MOBILE TOWERS SUBDIVISION

APPLICATION NUMBER 3 DATE September 18, 2014

REQUEST Subdivision

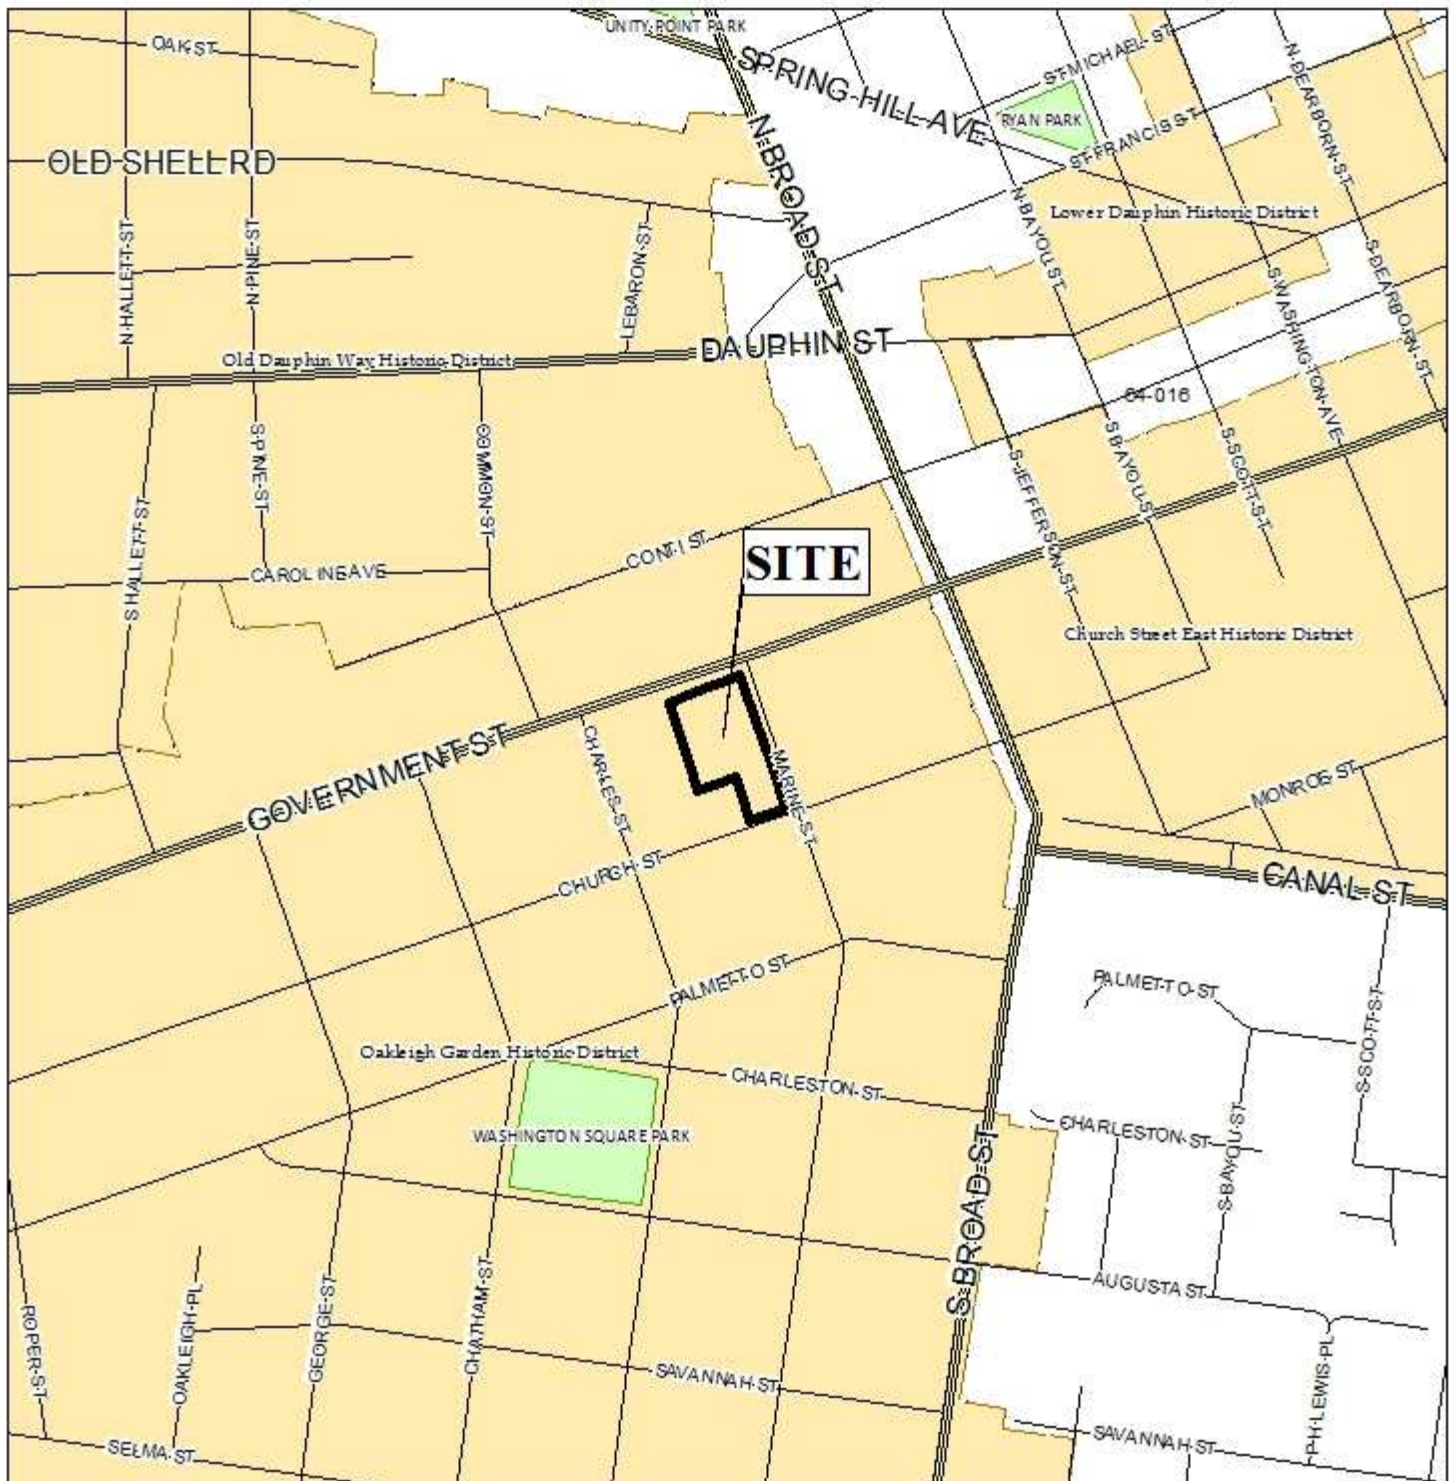
The site has frontage onto three streets: Government Street, a proposed major street with adequate right-of-way, Marine Street, a minor street with adequate right-of-way, and Church Street, a minor street with adequate right-of-way. However, dedication of the corner radii at Government Street and Marine Street as well as Marine Street and Church Street per Section V.D.6. of the Subdivision Regulations should be required.

Access management is a concern due to the site abutting Government Street, an ALDOT controlled facility due to the presence of US Highway 90. The site has existing curb-cuts onto Government and Marine Streets. Existing large live oak trees along Government Street will require Urban Forestry review should any changes be proposed to the curb-cuts along Government Street. The site should be limited to the two existing one-way in and one-way out curb-cuts onto Government Street and one two-way curb-cut onto Marine Street, with access to Church Street denied, with the size, design and location subject to Traffic Engineering, Urban Forestry, and ALDOT approval, as appropriate, and with modified or new curb-cuts complying with AASHTO standards. Any unused curb-cuts should be removed and landscaped with sod, with appropriate right-of-way permits.

The preliminary plat does not depict the 25-foot minimum building setback line, required by Section V.D.9. of the Subdivision Regulations. The setback line should be depicted along all frontages on the Final Plat, if approved.

- 1) dedication of the corner radii at Government Street and Marine Street as well as Marine Street and Church Street per Section V.D.6. of the Subdivision Regulations should be required;

- 2) placement of a note on the plat stating that the site is limited to one in and one out curb-cut onto Government Street, and one two-way curb-cut to Marine Street, with the size, design and location to be approved by Urban Forestry, Traffic Engineering and ALDOT, and to comply with AASHTO standards;

- 3) placement of a note on the plat stating that the site is denied access to Church Street;
- 4) removal of unused curb-cuts along Marine Street and replacement with curb and gutter, sodding, and sidewalk as necessary, with the appropriate right-of-way permits;

- 5) depiction of the 25-minimum building setback along all street frontages;
- 6) compliance with Engineering comments (*The following comments should be addressed prior to submitting the FINAL PLAT for acceptance and signature by the City Engineer: Provide all of the required information on the SUBDIVISION PLAT (i.e. signature blocks, signatures, certification statements, written legal description, required notes, legend, scale, bearings and distances) that is required by the current Alabama State Board of Licensure for Professional Engineers and Land Surveyors. Add a note to the SUBDIVISION PLAT stating that a Land Disturbance permit will be required for any land disturbing activity in accordance with the of the Storm Water Management and Flood Control Ordinance (Mobile City Code, Chapter 17 , Ordinance #65-007 & #65-045), latest edition. Storm water detention may be required for any existing development (since 1984) that did not receive Land Disturbance permitting and for any future*
